Title		
Face Detection Attendance Machine iF11		
Size	Number	Revision
C		
Date:	1/05/2025	Sheet of
File:	D:\Altium\...\iF11M.SchDoc	Drawn By: Blu

Battery Charging & Protection

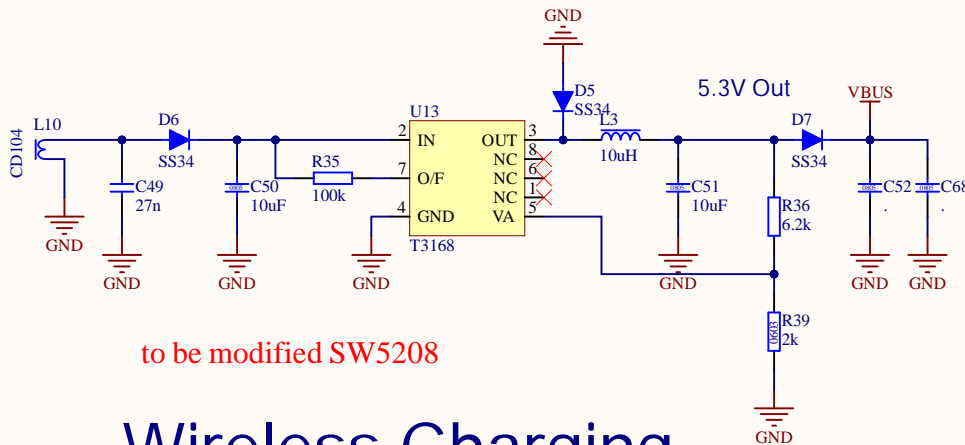
R38 should be adjusted for preferred battery charging Current

to be modified SW5208
